# 1990 Corvette: Service Bulletin: Information on Door Lock System Components and Replacement Components

**Bulletin Number:** 90-375-10 - (10/25/1990)

**Figure 1**

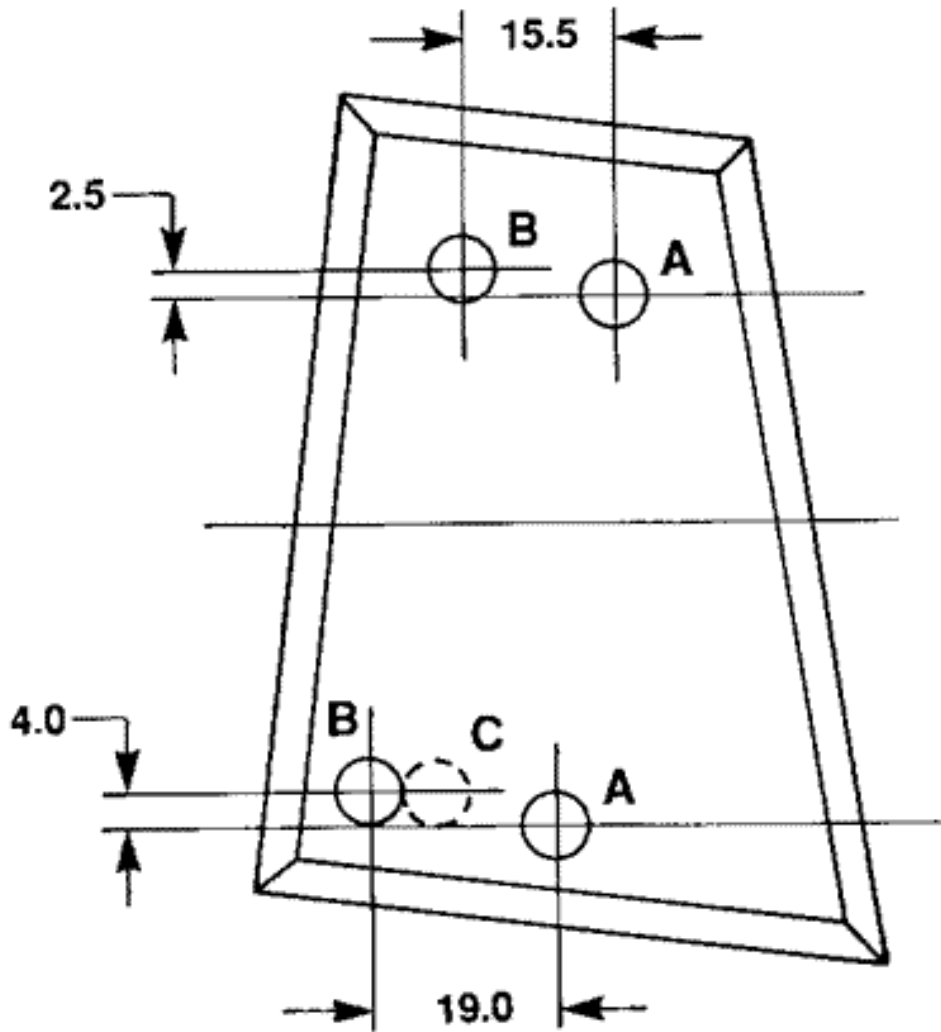
In addition to replacing the above components, it may be necessary to relocate the power door lock actuator on the door inner panel. Figure 1 will illustrate the hole patterns.

- If the actuator is located in the holes marked "A," it will not need to be relocated.

- If the actuator is located in the holes marked "B";
- remove the actuator by drilling out the attaching rivets.
- locate the new attaching holes ("A") using the dimensions on the illustration.
- attach the actuator in the new location using 1/4" X 1/2" peel type rivets.

**IMPORTANT: Hole "C" may or may not be present. Relocate holes from "B" locations only.**
